Greenbelt Joint Development Public Hearing Staff Report

**R16-01: Proposed Changes to WMATA Facilities at Greenbelt Metro
Station/Compact Public Hearing No. 608**

Staff Analysis of the Public Hearing and Staff Recommendations

Washington Metropolitan Area Transit Authority

Figure 1: Proposed Joint Development Concept

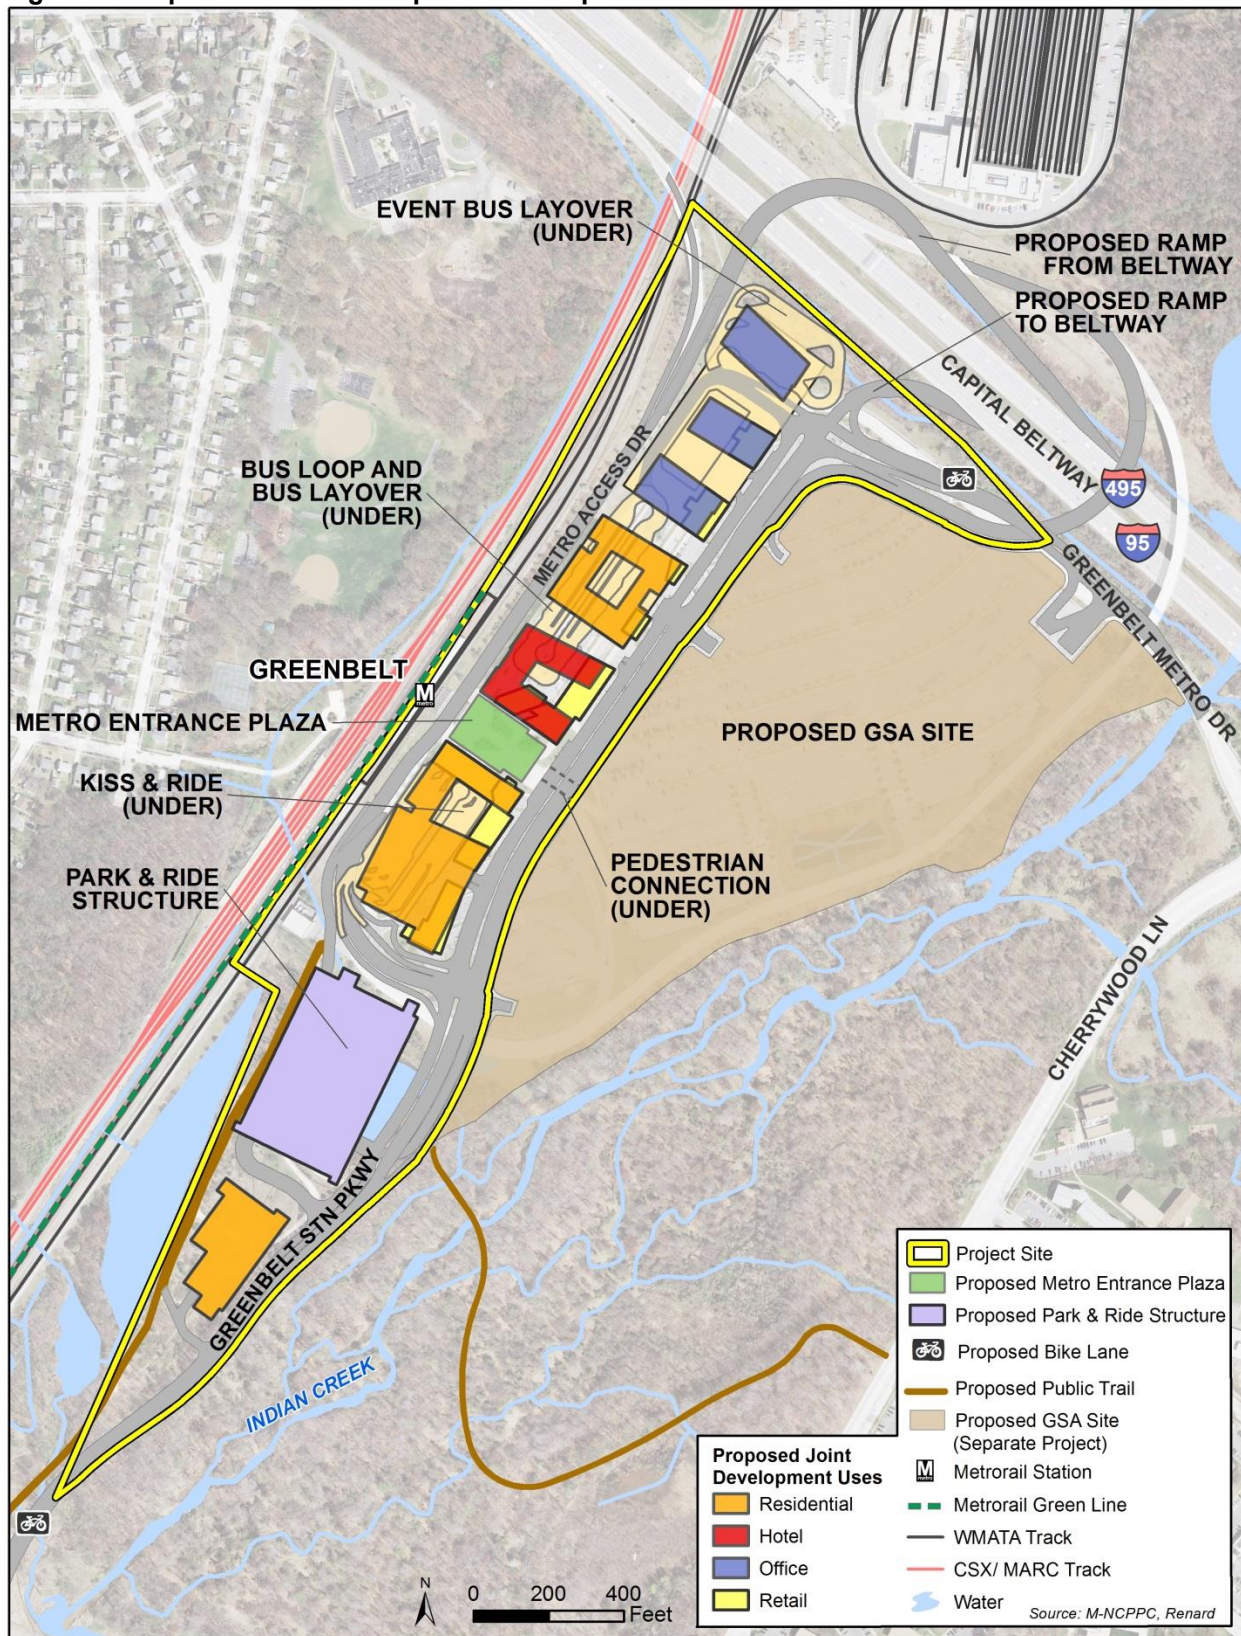
Some participants advocated for a less "auto-dominated" and more "pedestrian-oriented" station area design and criticized design elements such as wide roadways, large blocks, and inadequate numbers of street trees, pedestrian refuges (medians), crosswalks, and street-level retail spaces. The design concept for the proposed project was completed by the developer in coordination with WMATA. The project will include signalized pedestrian crosswalks along Greenbelt Station Parkway, providing safer and shorter pedestrian connections along the eastern side of the project site. A variety of urban design, technical, economic, regulatory, and other factors will be further considered as the design advances. WMATA staff will relay these public comments to the developer and other local jurisdictional agencies involved and attempt to incorporate improvements to enhance the pedestrian experience.

Two respondents were concerned about the one-way configuration of Metro Access Drive and its effect on pedestrian safety and vehicle speeds. Metro Access Drive is elevated so there will be no pedestrian or vehicular conflict for pedestrians accessing the station from the Park & Ride, Kiss & Ride, or bus loop. Where Metro Access Drive is at grade at the intersection of Greenbelt Station Parkway, there is a signalized pedestrian crossing.

Two respondents expressed concern about the traffic flow in the Kiss & Ride pick-up area and stated that the existing Kiss & Ride lot does not adequately accommodate turn-arounds and cars are often stopped in prohibited areas. WMATA staff expects that the proposed Kiss & Ride facility would be an improvement over the existing facility. While traffic from the Beltway, Kiss & Ride, and the Park & Ride would all utilize the same space, the one-way nature of Metro Access Drive would limit the potential for vehicular conflict. Additionally, the Kiss & Ride would be accessed via separate access ramps along the southern portion of Metro Access Drive between the Kiss & Ride and Park & Ride structure.
